# MISSOURI 2019 AIRPORT LIGHTING PACKAGE

## WEST PACKAGE

## ADDENDUM NO. 1

November 2, 2020

Drawing Name: I:\AV\PRJ000015616\01 - MODOT 7 PACK\AE03 - ACAD\AVA (AOV)\PRODUCTION DRAWINGS\15616 Ava - Vault and System Details.dwg Nov 02, 2020 - 2:45pm Saved By: wright 2020/11/02 Plot Style: ae.ctb Layout Name: DISTRIBUTION SCHEMATIC

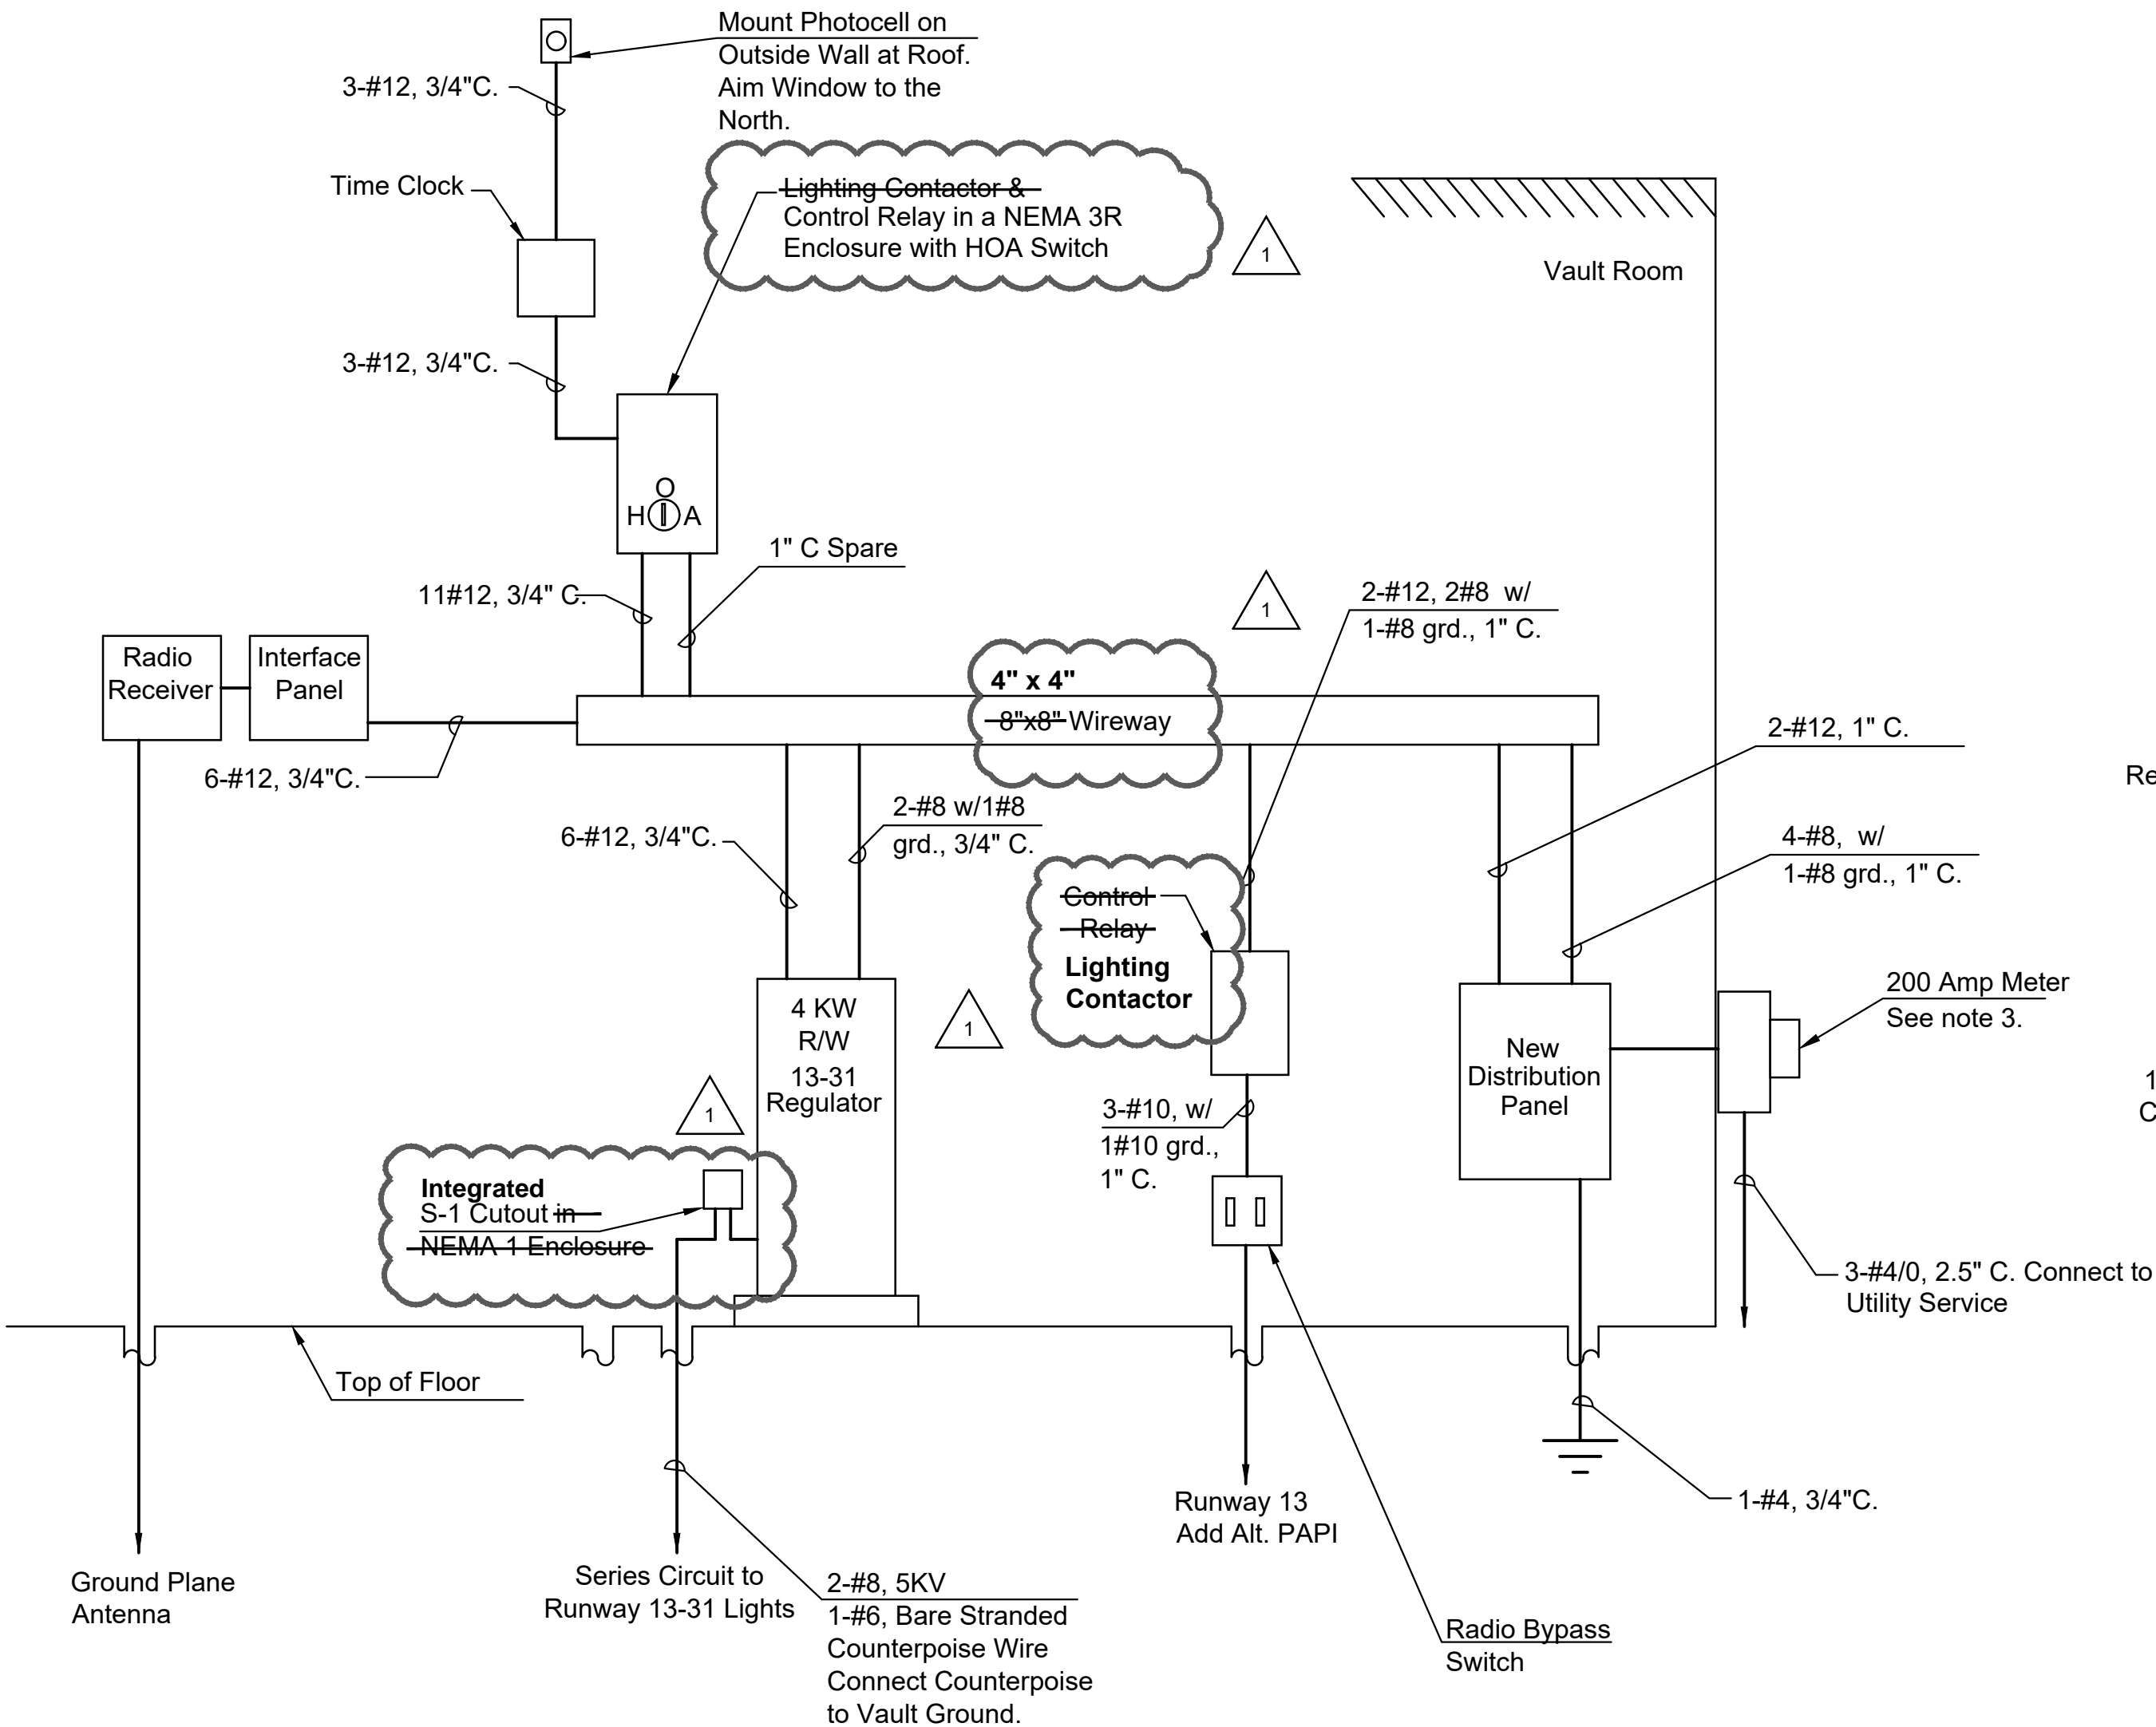
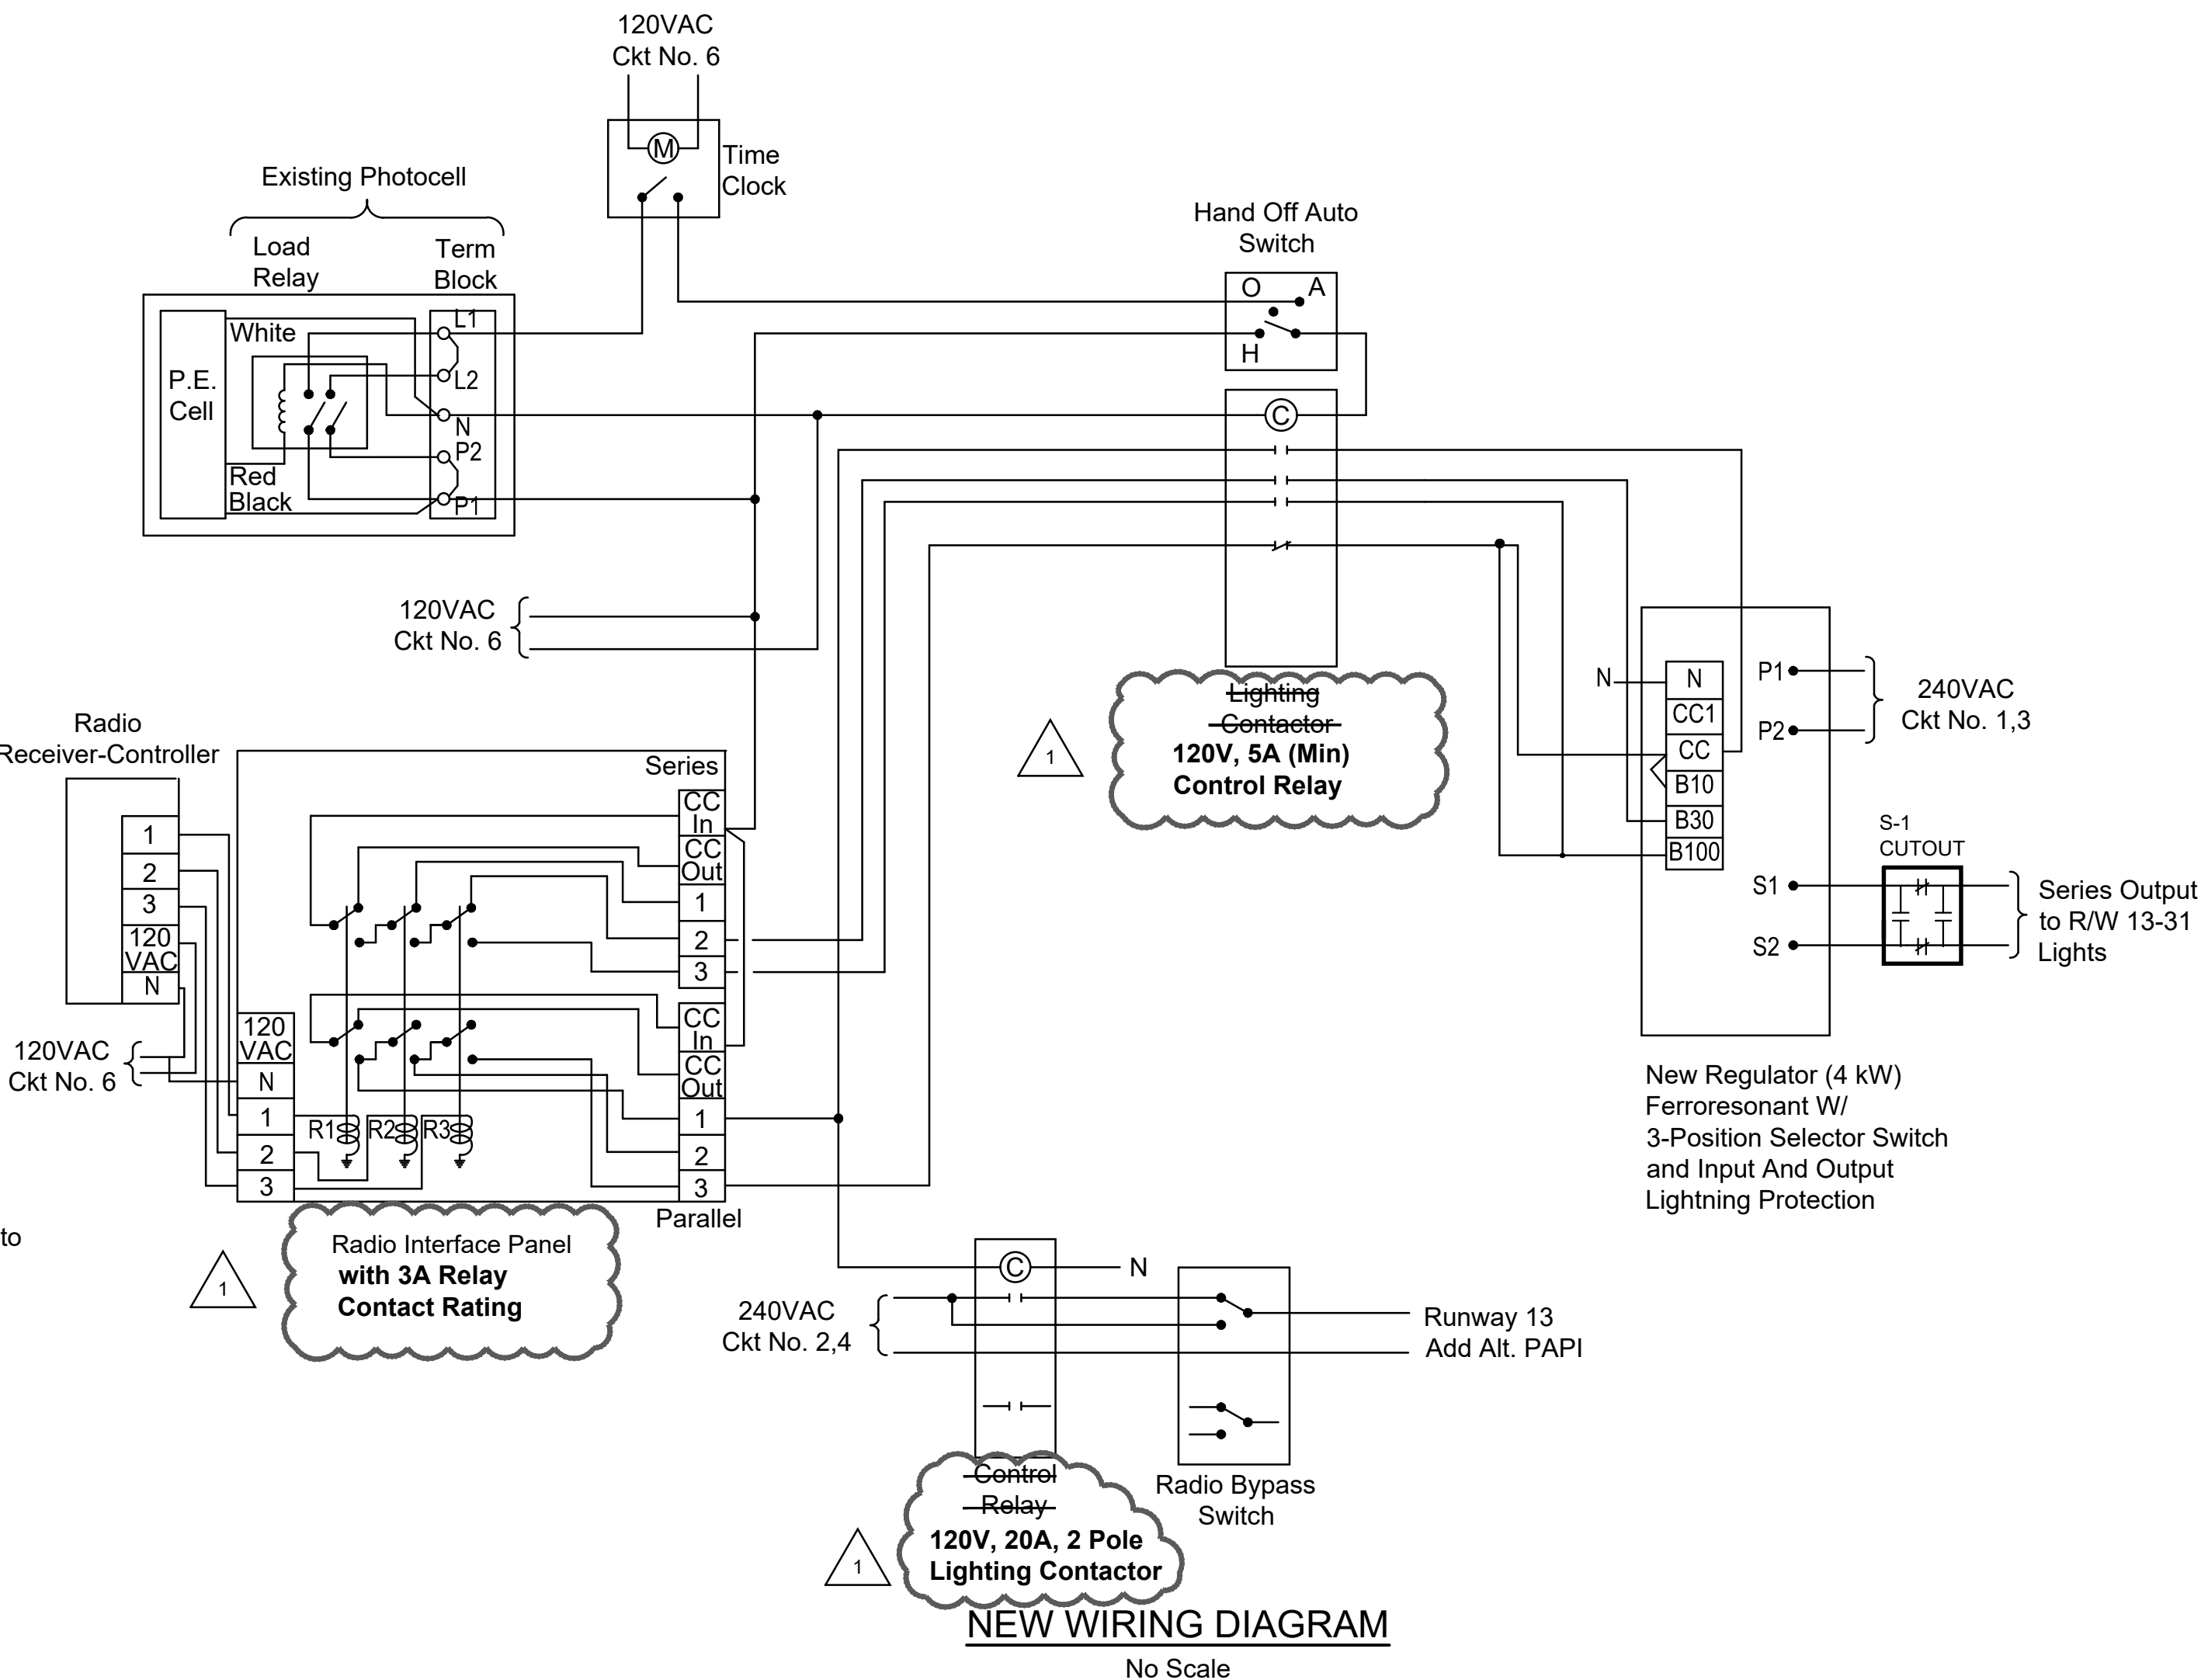
8. **Schedule D: Ava Bill Martin Memorial Airport**, Sheet No. 15 Distribution Schematic. The 8" x 8" wireway is now a 4" x 4" wireway. The 100A lighting contactor for the regulator, was removed. The regulator will now be controlled via a 120V, 5A (minimum) control relay. The PAPI control relay is now a 20A, 2 pole lighting contactor. Radio interface specifications were added to the label, and the callout for the S-1 cutout revised to indicate that this is to be integrated with the regulator. The Distribution System Elevation and Wiring Diagram Schematics were updated to reflect these changes.
